## REVISED RESPONSE TO REQUEST FOR ADDITIONAL INFORMATION

### APR1400 Design Certification

Docket No. 52-046

RAI No.: 129-8085  
SRP Section: 03.08.01 – Concrete Containmentment  
Application Section: 3.8.1  
Date of RAI Issue: 08/05/2015

**Figure 1 Section of Containment around IRWST**

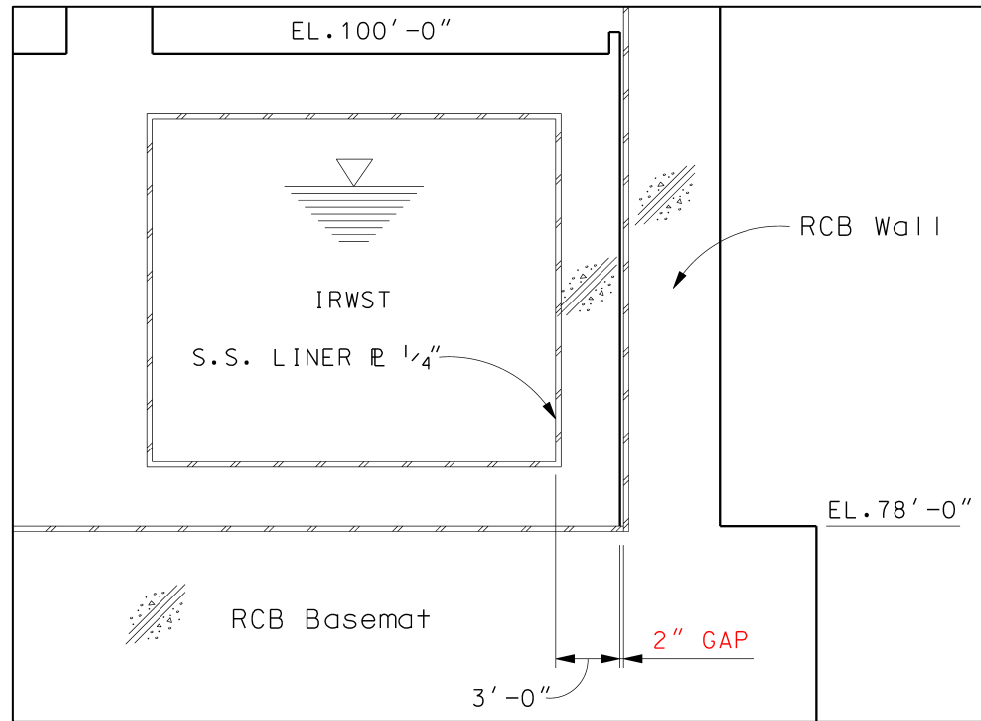
- e. Explain where in DCD Sections 3.8.1.3 and 3.8.3.3 the load descriptions and load combinations for consideration of safety/relief valve actuation loads on the containment and containment internal structures are described and whether or not the safety/relief valve actuation loads include potential direct loads on the structures and potential building dynamic response loads.

- e. DCD Tier 2, Subsection 3.8.1.3 does not describe pilot-operated safety relief valve (POSRV) actuation load since POSRV actuation loads are not applied on the containment wall. The IRWST is separated from the containment wall by a gap of 2 inches, as shown in Figure 1 below. Thus, there is no connection to transfer POSRV actuation loads to the containment wall. Therefore, POSRV actuation loads are not applied to the containment basemat through the containment wall. DCD Tier 2, Subsection 3.8.3.1.8 will be revised, indicated in the attachment associated with this response.
